RE: **Lot 4 Block 5, S.A.D. 227**  
**Unser Cliffs Subdivision**  
**6512 Onyx Ct. NW**  
**Grading and Drainage Plan**  
**Engineers Stamp Date 1-3-20 (E10D071)**

MARTINEZ — LOT 4 GRADING & DRAINAGE PLAN

## RESPONSE TO COMMENTS

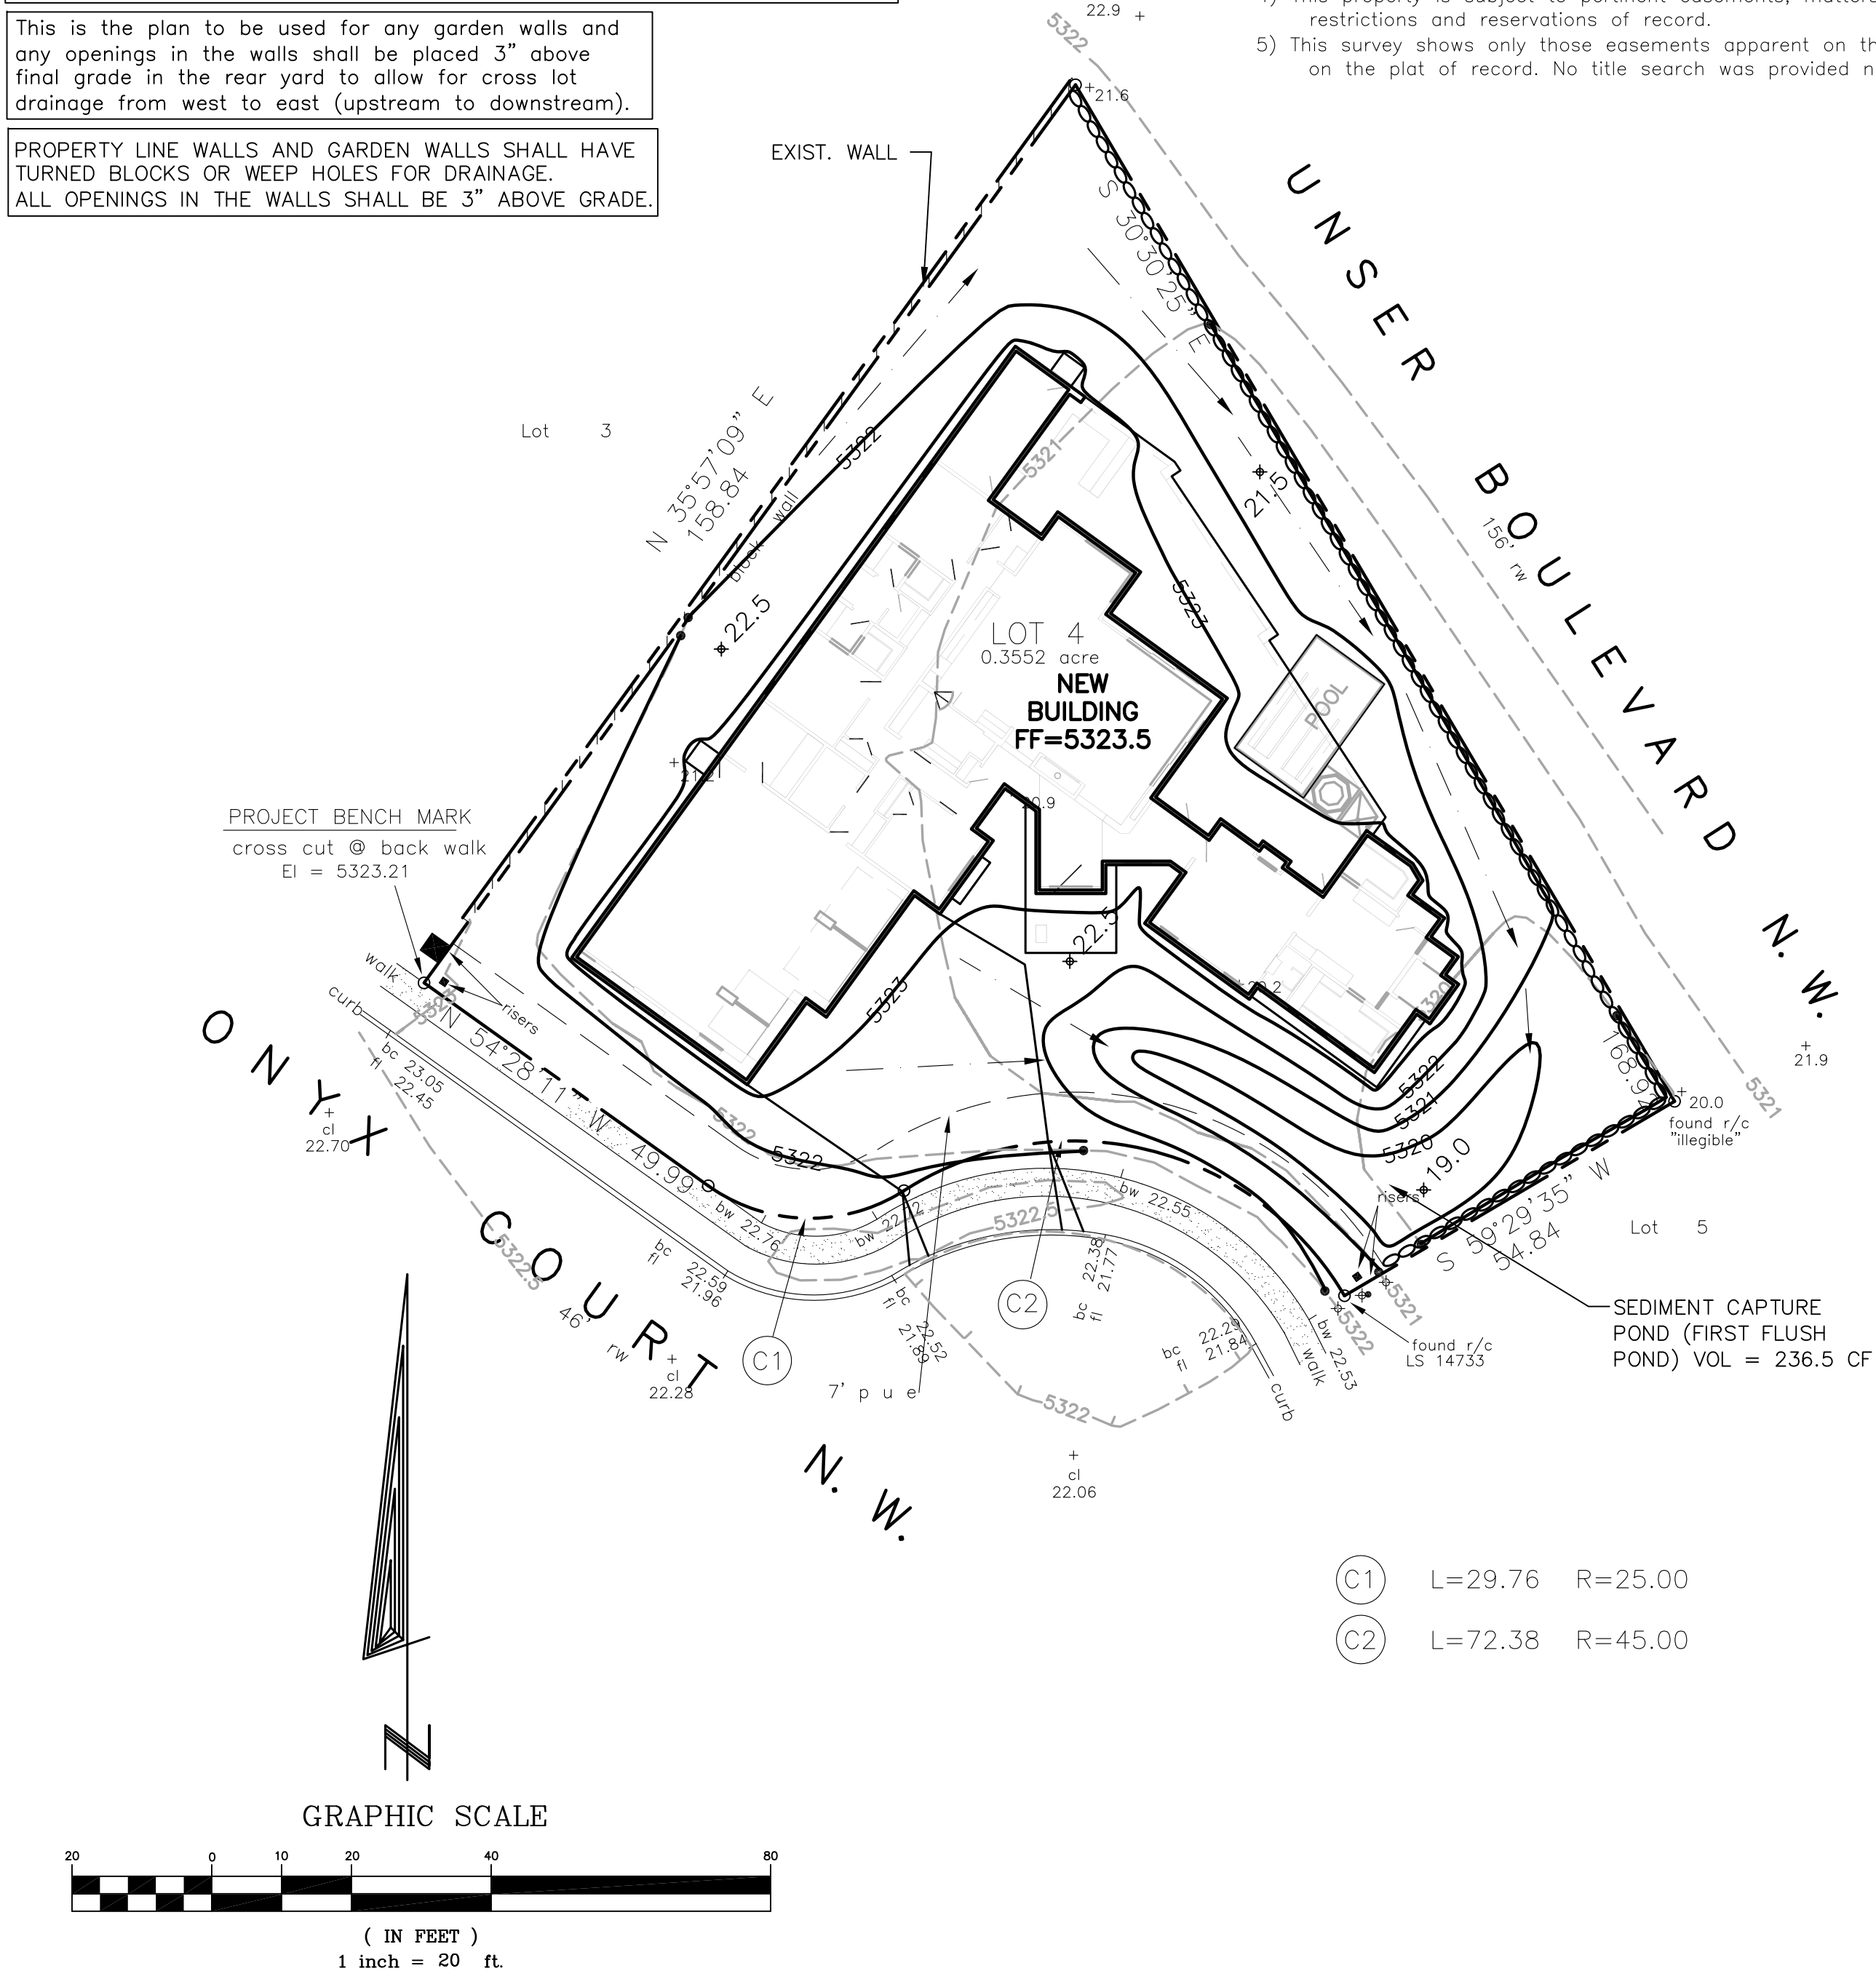
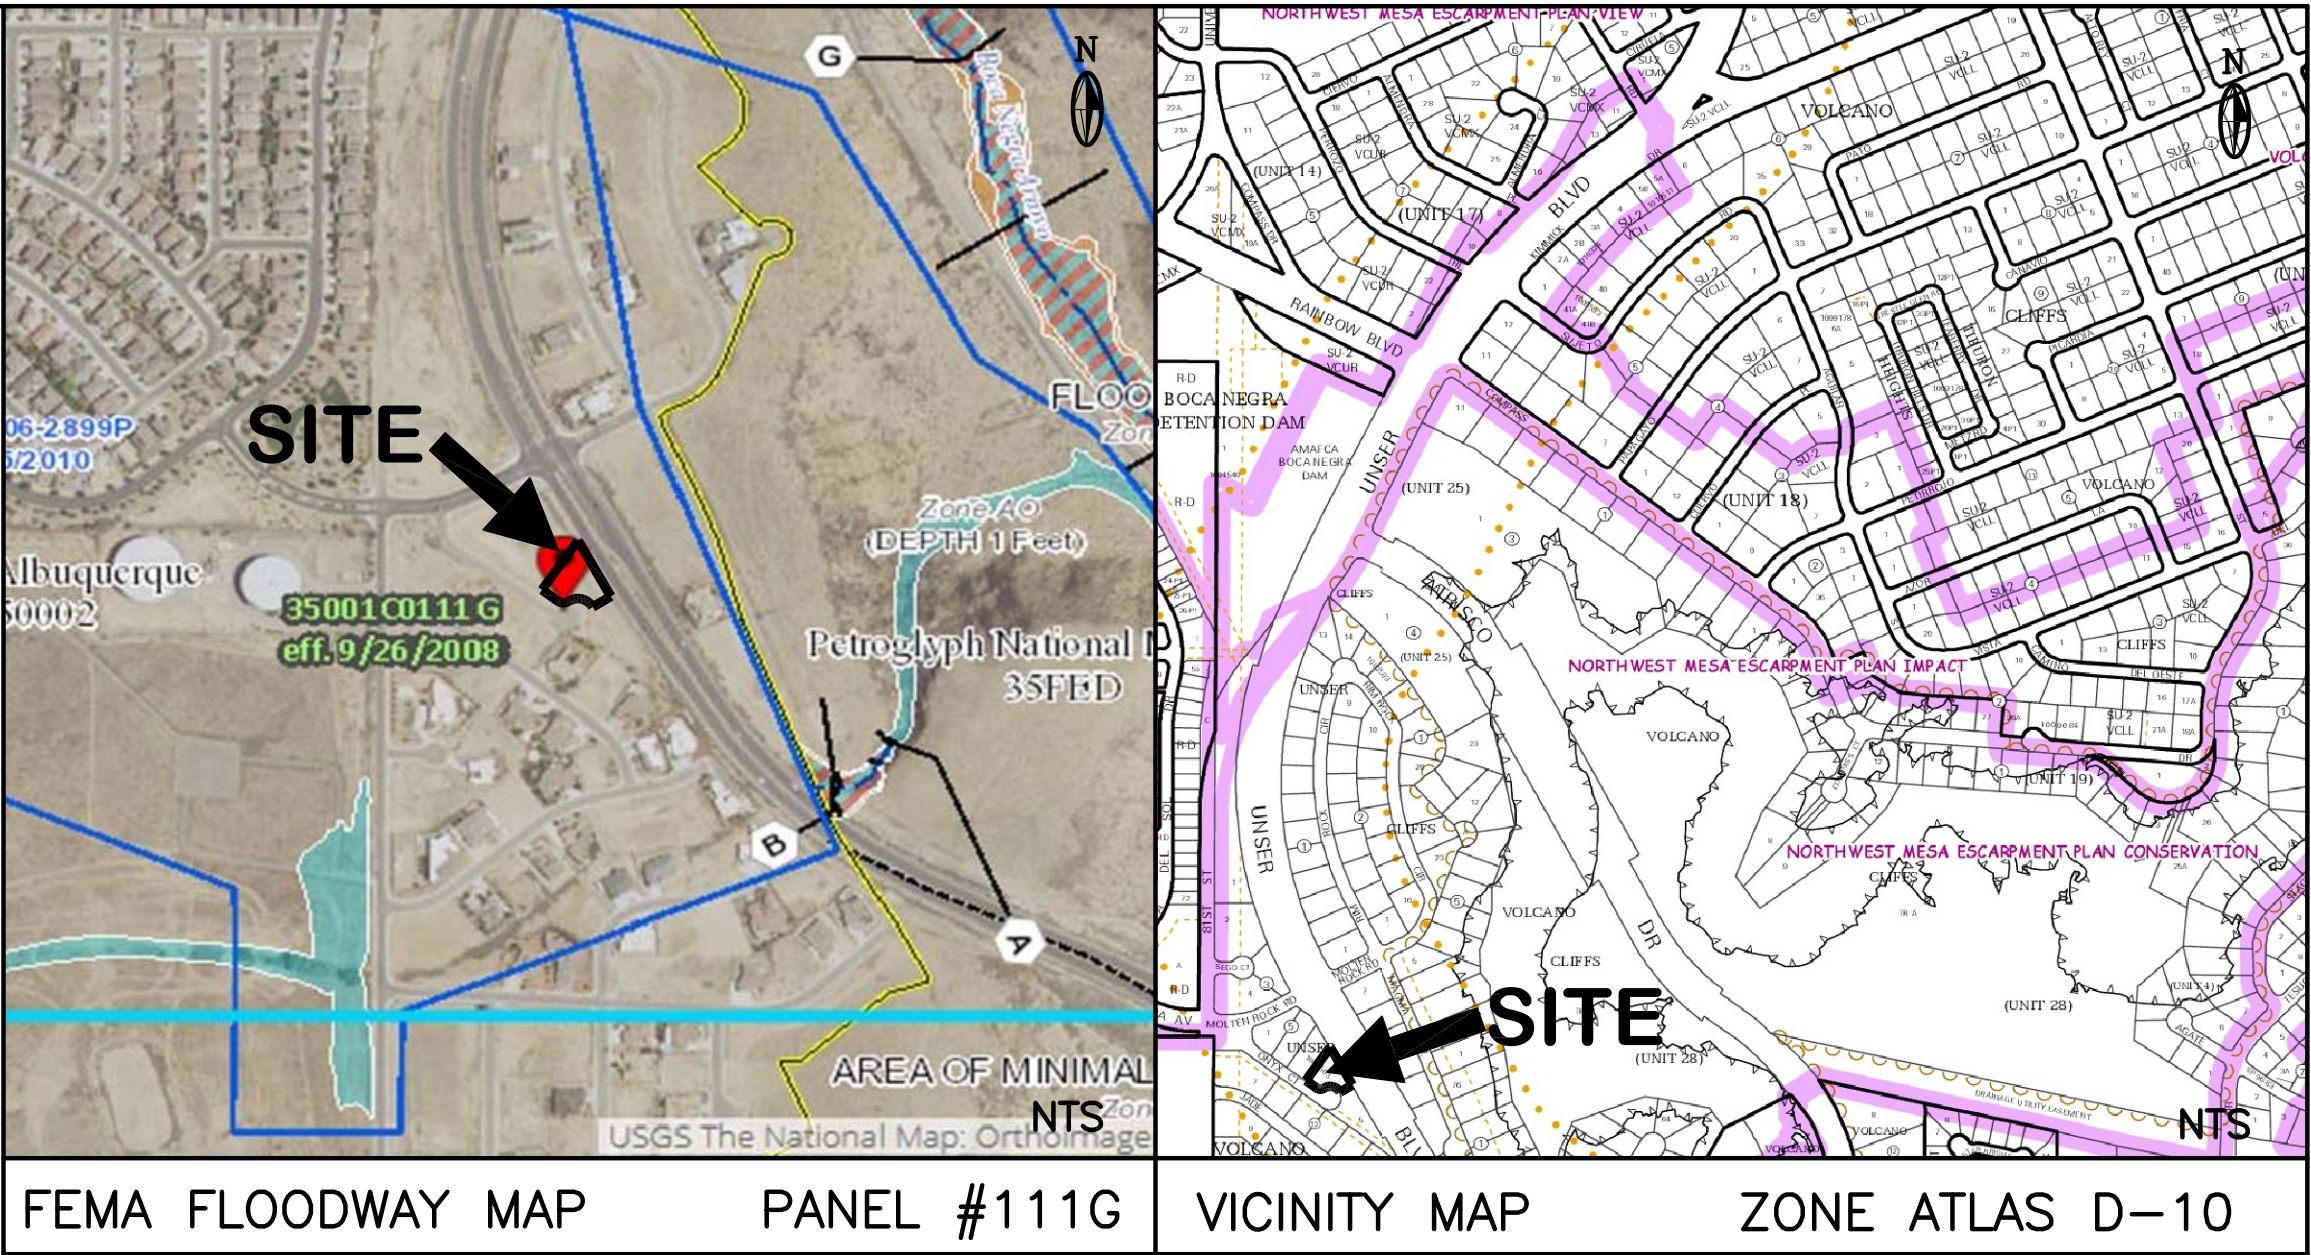
- Direct all flows to exit onto Onyx Ct. through a sediment capture pond. **OK- revised**
- Cross lot drainage is not required; remove the turn blocks on the eastern garden wall. **OK- revised**
- Provide a percentage for land treatment C. **OK - revised**
- Notify the owner/contractor not to use dirt as a ramp to climb the curbing, may use lumber or crusher fines for this function. **The owner is copied with this response.**
